PLANNING COMMISSION MEETING

City Hall: 3750 Bridge NW Wednesday, April 16, 2025 at 7:00 PM

SUBJECT: St. Francis Apartments Concept Review

APPLICANT: North Shore Development Partners

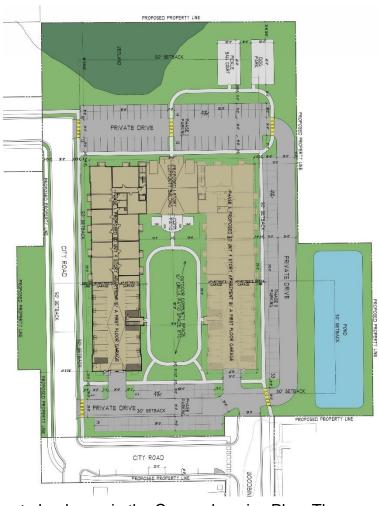
move forward, a Comprehensive Plan Amendment would be needed to reclassify these properties as High Density Residential use (12-20 units per acre). Even with this designation, the proposed density of 120 units on 4.25 acres (28 units per acre) is greater than what is allowed. In order to meet the density requirements, the number of units would need to be reduced to 85, the size of the development would need to be increased to 6 acres, or some combination of the two adjustments would need to be made.

With the inclusion of the new public road, the site would have two front yards (west and south). Each front yard would require a setback of 30 feet. Interior side yard setbacks are 10 feet and the rear yard setback is 25 feet. As shown, the building placement would need to be adjusted in order to meet the front yard setback to the west. A 50 foot setback is required from the R-1 zoned properties to the east; this distance appears to be met.

The applicant is proposing first floor enclosed parking spaces for each phase of construction (total number of spaces unknown) with 52 phase 1 surface lot spaces and 66 phase 2 surface lot spaces (118 total). Required parking for apartment buildings is based on the type of unit (number of bedrooms). Without floor plans, it cannot be determined if the proposed parking meets the City's requirements. However, at least one space per unit must be enclosed which equates to 120 enclosed parking spaces.

No parking is allowed within 5 feet of a property line. Along the west property line, the parking setback may need to be adjusted.

building divided by 320. Other landscaping standards require a diversity of species. As currently shown, there are long stretches of the parking lot lacking landscaping – parking lot islands with trees should be considered.

Site standards limit impervious coverage to 50% of the area. When the second phase of the building and additional parking lots are constructed, this threshold may be surpassed.

As submitted, the current concept does not align with some City regulations – primarily with respect to the maximum density allowed on the site, which also relates to the required lot area per unit. Minor questions remain to be addressed around setbacks and landscaping which will be evaluated as more refined plans are developed.
